Access Compliance Report

Public Rights-of-Way

Intersection ID: 17448	Main Street: AMBER_CRESTE_LN	Cross Street: CITY_VIEW_DR	Location: NW
ADA ID: B2015A2B0BBC	Ramp Type: PerpDiag	Initial Pass/Fail: Fail	Overall Compliance: No
		Severity Score: 12.5

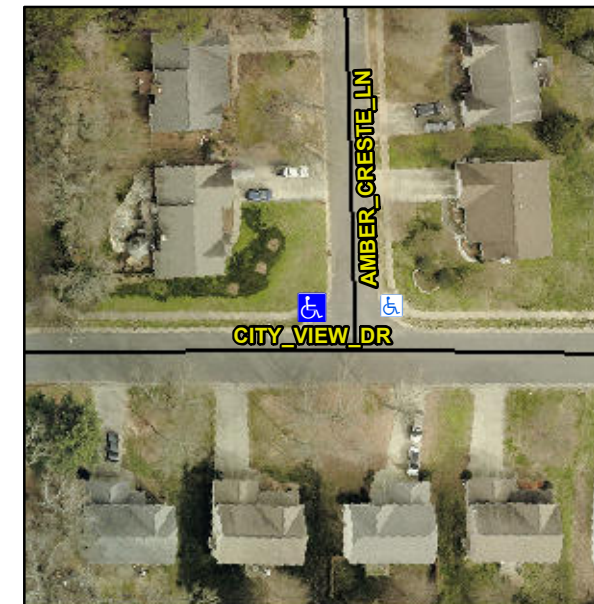
Compliance	Description	Data	Compliance	Description	Data
N/A	Ramp Length (in)	51.0	No	Ramp Slope (%)	8.6
Yes	Ramp Width (in)	48.0	Yes	Ramp XSlope (%)	0.7
N/A	Flare Type LT	N/A	N/A	Flare Type RT	N/A
N/A	Flare Slope LT (%)	N/A	N/A	Flare Slope RT (%)	N/A
N/A	Flare Traversable LT?	N/A	N/A	Flare Traversable RT?	N/A
N/A	Landing Length (in)	N/A	N/A	DWS Provided?	N/A
N/A	Landing Width (in)	N/A	N/A	DWS Contrast?	N/A
N/A	Landing Slope (%)	N/A	N/A	DWS Length (in)	N/A
N/A	Landing X Slope (%)	N/A	N/A	DWS Full Width?	N/A
N/A	Landing Curb? (Y/N)	N/A	N/A	DWS Offset (in)	N/A
N/A	Shared Landing?	N/A			
N/A	Gutter Ponding?	N/A	N/A	Gutter Slope (%)	N/A
N/A	Gutter Lip Ht (in)	N/A	N/A	Gutter X Slope (%)	N/A
N/A	Painted X Walk1?	No	N/A	Painted X Walk2?	No
	X Walk 1 Direction	To S		X Walk 2 Direction	To SE
N/A	X Walk 1 Width (in)	N/A	N/A	X Walk 2 Width (in)	N/A
	X Walk 1 Slope (%)	0.8		X Walk 2 Slope (%)	1.3
	X Walk 1 X Slope (%)	0.0		X Walk 2 X Slope (%)	2.0

Possible Solutions:

Remove & Replace Curb Ramp With Two New Directional Ramps or Equivalent.
